# UNITED STATES PATENT AND TRADEMARK OFFICE

APPLICATION NO.	FILING DATE	FIRST NAMED INVENTOR	ATTORNEY DOCKET NO.	CONFIRMATION NO.
10/522,876	02/02/2005	Mitsuo Tashiro	FP3002-0036	5251
39083 7590 04/11/2008 CERMAK KENEALY & VAIDYA, LLP 515 EAST BRADDOCK RD SUITE B Alexandria, VA 22314				
EXAMINER				
GILBERT, ANDREW M				
ART UNIT		PAPER NUMBER		
3767				
MAIL DATE		DELIVERY MODE		
04/11/2008		PAPER

### Office Action Summary

## **DETAILED ACTION**

Annotated Figure 1: Huber '847

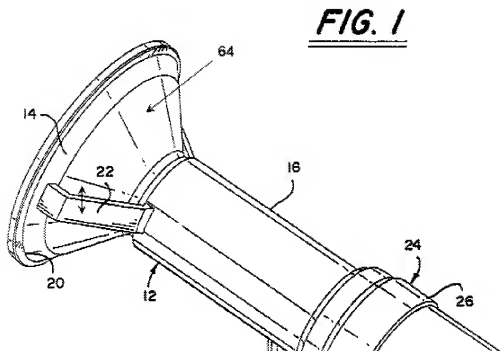
9. Applicant's arguments filed 2/21/2008 have been fully considered but they are not persuasive.
10. The Applicant argues that Huber '847 does not teach or suggest a space between the deformable member and the horn member.
11. In response to the Applicant's arguments, the Examiner notes that as shown in the annotated Figure 1 below, the arms of the horn member (22) are disposed over the

deformable member (60; at the surface area of 64). As indicated by the double arrow below, there is a space shown between the inner surface of the arms (22) and the outer surface of the deformable member (64). This space reads on the applicant's recitation of "a space between the deformable member and the horn member. Under application of negative pressure this space changes in volume as the outer surface of the deformable member (64) is deformed inwardly towards the breast under the force of the negative pressure. The inner surface of the arms (22) do not move because they are rigid – thus, a change in volume and spacing between the two elements occurs under negative pressure and returns to normal spacing upon release of negative pressure. The examiner further comments that the applicant has not in the independent claims provided structural recitations in the claims that describe the size, shape, or relative placement of the vent openings, size of the horn member relative to the deformable member, or size of the spacing between the horn member and the deformable member. Some aspects have been claimed in newly submitted claims 25-27 and the examiner recommends further detailing such aspects of the applicant's claim invention and incorporating the limitations into the independent claims to distinguish the applicant's claimed invention over the prior art of record.
